Office Action Summary

10/720,173

HAN, EUN-BONG

DETAILED ACTION

FIG. 1
(PRIOR ART)

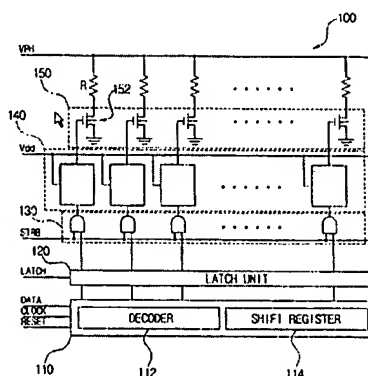
- {claim 1} An inkjet printer head driving apparatus having a plurality of heating elements and nozzles (figure 1, reference 100); a switching unit turning on and off each of the heating elements to heat ink corresponding to selected nozzles to eject the ink (figure 1, reference 150); a level shift unit having a level converter converting a potential level of a signal inputted therein into a predetermined potential level to drive the switching unit (figure 1, reference 140), a buffer to output the converted level of the signal (figure 2, reference 144), and a transient time extending part provided with at least one time extending element to extend by a predetermined time a transient time of the output potential level of the signal during which the potential level of the signal inputted from the level converter to the switching unit is converted from a first signal level to a second signal level and vice versa (figure 1-2, reference 140); a control unit receiving an external

data signal, decoding the received data signal, and outputting the decoded data signal as a nozzle selection signal to the level shift unit to select the selected nozzles corresponding to a to-be-recorded image from the nozzles (figure 1, reference 110)

- {claim 8} An inkjet printer head driving apparatus having a plurality of heating elements and nozzles (figure 1, reference 100); a control unit generating a control nozzle selection signal to select a heating element and a nozzle corresponding to an image to be printed (figure 1, reference 110); a level shift unit generating a first nozzle selection signal having a first transient time, during which a level of the first nozzle selection signal is changed between first and second levels, in response to the control nozzle selection signal, and generating a second nozzle selection signal having a second transient time extended by a period from the first transient time of the first nozzle selection signal (figure 1-2, reference 140); and a switching unit turning on and off the heating element according to the second nozzle selection signal (figure 1, reference 150)

- {claim 31} An inkjet head driving unit (figure 1); a control unit to generate a nozzle selection signal to select a nozzle having a heating element (figure 1, reference 110); a level shift unit to convert the nozzle selection signal to have a predetermined level to drive the heating element between a logic high and a logic low and having a buffer to output the converted nozzle selection signal (figure 2, reference 144), and one or more logic units to increase a time required to change the output nozzle selection signal between the logic high and the logic low (figure 1-2, reference 140); and a switching unit to turn the heating element on and off according to the output of the level shift unit (figure 1, reference 150)

The examiner respectfully disagrees. The examiner has repeatedly demonstrated that the AAPA discloses the transient time extending part in the fact that the right part of buffer 144 discloses a first PMOS and first NMOS which necessarily extends the transient time, even though the extent of this function may be minimal or even negligent when compared to the time extending characteristics of transient time extending part 243. The applicant still has not rebutted these arguments with respect to figure 6.
